Ref/Job No: **18SYD-9618**

22 March 2019

Re: OEH Submission to Eastern Creek Business Hub SSD 5175 Modification 4 - Biodiversity Impacts

Figure 1 – Provides clarity around the decreased impact to Shale Plains Woodland (SPW) and the removal of any impacts on Alluvial Woodland (AW), providing decrease in impacts to native vegetation.

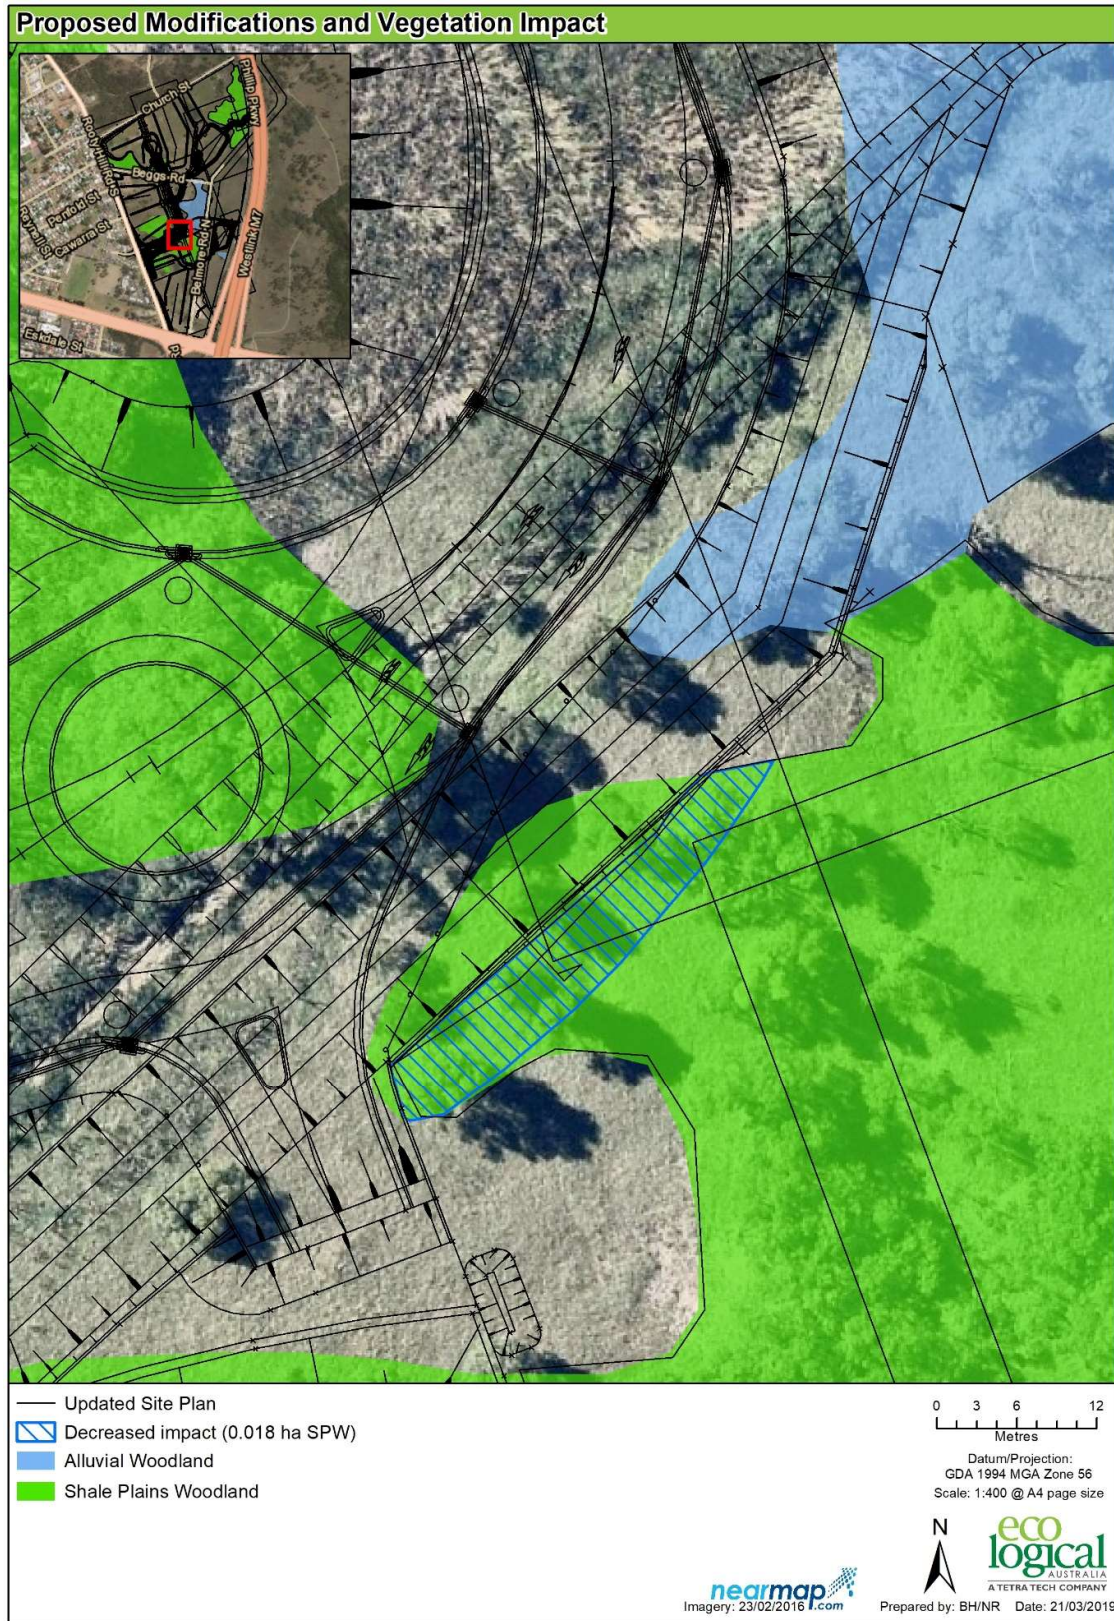
OEH required clarification on whether the proposed changes would impact on an offset area.

Additionally, as per **Biodiversity 1**, OEH have noted that previous mapping was not clear in its intention/description of change to impacts.

In response to the fact that the proposed modification involved minor additional impacts to vegetation within the ECA, being 0.002 hectare loss of Alluvial Woodland, Frasers Property Australia have redesigned the stormwater channel batters to remove said impact. This redesign means that the Modification now only involves a *reduction* in impacts to Shale Plains Woodland (SPW).

As requested, **Figures 1 and 2** below have been prepared to provide greater clarity around the change in impacts and clearly depict the updated design. Further, **Appendix 2** now provides previous mapping to give context to the current changes and proposed reduced impacts.

Figure 2 – As requested, provides context of the changes in relation to the ECA and the proposed VMP works.
